HORSHAM DISTRICT COUNCIL CONSULTATION

TO:	Horsham District Council – Planning Dept
LOCATION:	Chanctonbury Nurseries Rectory Lane Ashington Pulborough
DESCRIPTION:	Variation to condition 1 to approved application DC/22/0372 (Demolition of existing buildings and erection of 74 dwellings with associated parking and landscaping) To enable a substation to be provided.
REFERENCE:	DC/24/0977
RE-CONSULT:	1st set of comments in black 2nd set of comments in blue
RECOMMENDATION:	No objection

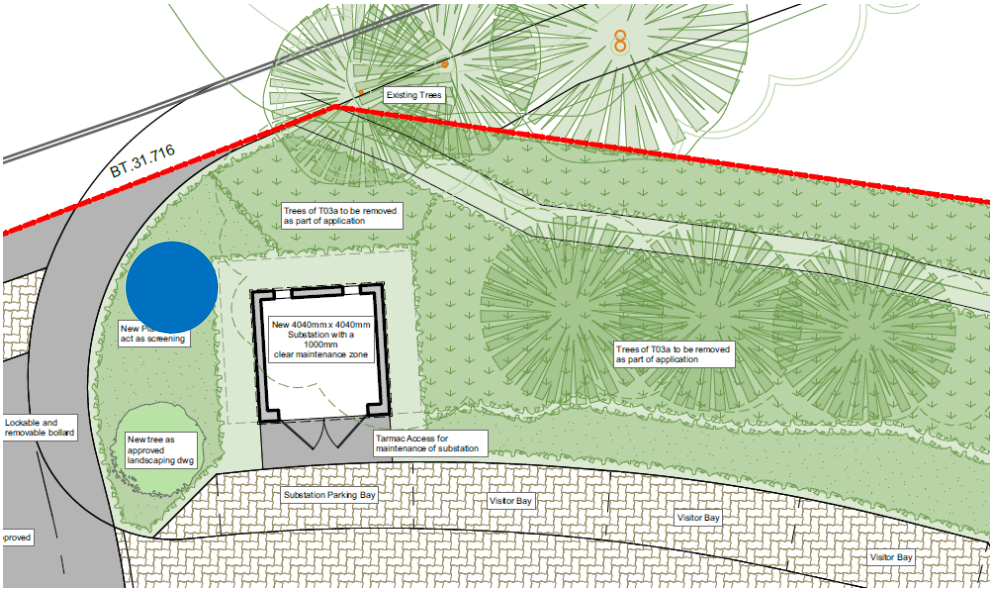
1. Proposals under DC/22/0372 and DISC/24/0129 set out to retain and enhance the northern boundary vegetation, with the intention of managing it for the benefit of biodiversity by allowing it to develop into a tall, dense, bushy structure maintained at a height of 3-4 metres. Please review section 4.3 of the LMP, 4.8.1

and 4.8.2 of the LEMP for proposed landscaping and sections 2.2.6.1-2, 2.4.2, 3.1.3-4 of the LEMP for ecological importance. Not yet addressed.

2. Proposals under DC/24/0977 state that the substation would be screened with a high quality landscaping scheme, however no detailed information has been provided. Not yet addressed. We recommend further tree planting in addition to the Heavy standard Quercus robur (see indicative location in blue below) along with a dense, mixed species, native hedgerow lining the boundary, to be maintained at a minimum 2m in height. This hedgerow should comprise native shrubs as seen elsewhere on site, such as Ilex aquifolium, Crataegus monogyna and Corylus avellana. These details can be secured via condition.

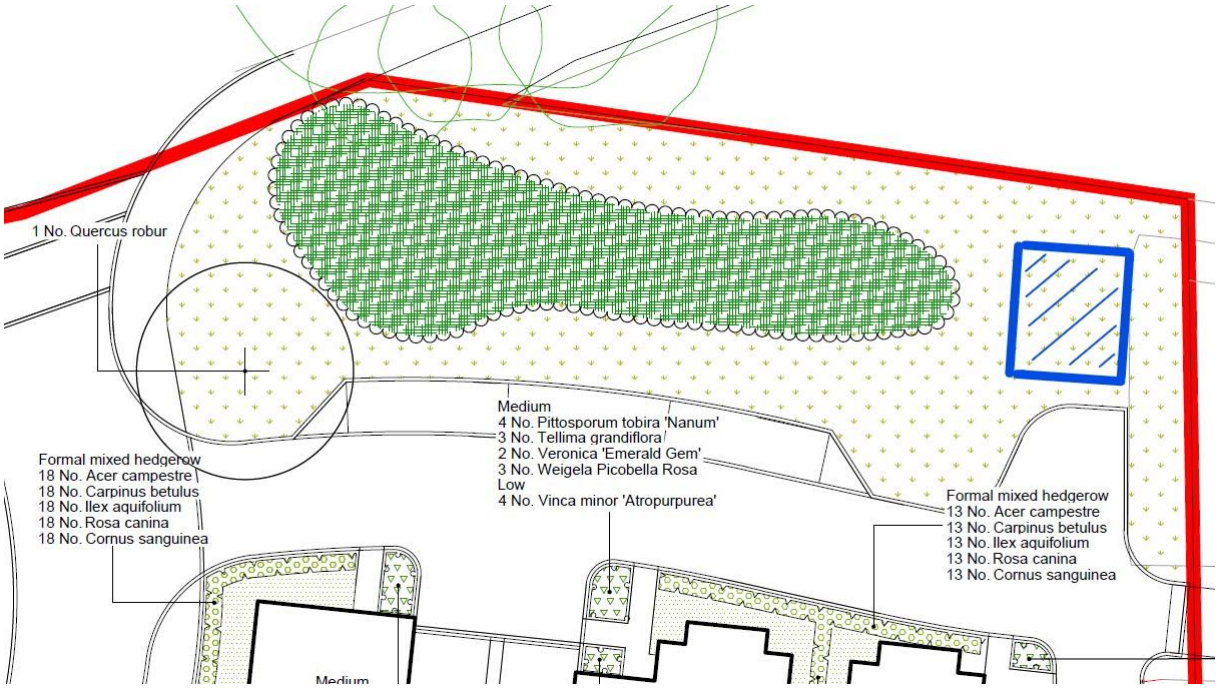
3. We recommend that the large area of vegetation on the northern boundary is retained for landscape, biodiversity and amenity benefit, and continue to recommend the addition of a Heavy standard Quercus robur in order to provide a designed sense of arrival and therefore improve visual amenity to the scheme. Tree reinstated, with thanks, however details (including girth size and specimen) must be secured by condition.

4. As an alternative, we recommend locating the substation to the east of the retained and enhanced vegetation, where it will be relatively well screened by existing vegetation and the currently proposed hard surfacing can be utilised for maintenance. (See below in blue for indicative location) Alternative location proposed, with thanks.
